Comments on the Justification for the Lower Churchill Transmission Project (Labrador-Island Transmission Link)

submitted to the
Canadian Environmental Assessment Agency
Comprehensive Study on the Lower Churchill
Transmission Project

on behalf of Grand Riverkeeper Labrador Inc.

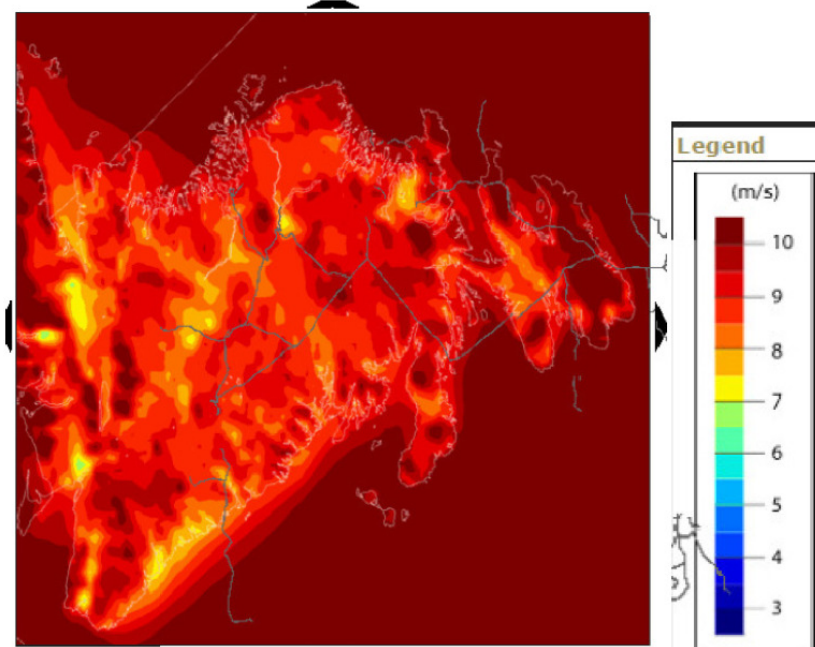
The following chart, drawn from my April 13, 2011 submission to the Joint Review Panel,¹⁸ demonstrates that CDM funding by NLH and by NP lagged far behind that which was projected in their Five-Year Joint CDM Plan.

This is not particularly surprising: Most utilities perform very poorly when they first begin to pursue CDM savings. What is surprising is that, based on its admittedly poor performance in the first years of its CDM program, **NLH has chosen to exclude consideration of CDM savings as a resource in its 50-year power plan.** I am not aware of any other utility in North America that has so blatantly disregarded CDM as a resource.

Comparison of Revised and Sixth Plan Oil Price Forecasts
Refiners Acquisition Cost \$2010/barrel

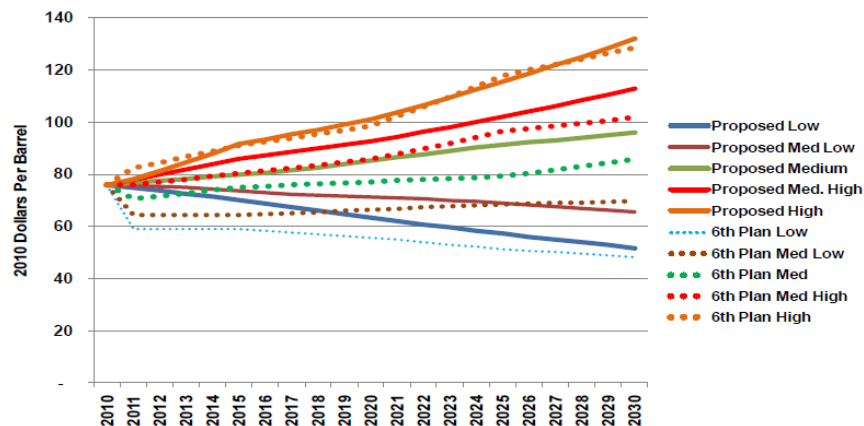
The PIRA high and low forecasts have not been made public, so to get an idea of the extent of the typical spreads between high and low oil price forecasts, I had to look to other sources. The following chart presents the oil price forecast from the Northwest Power Planning Council's 2009 Power Plan.
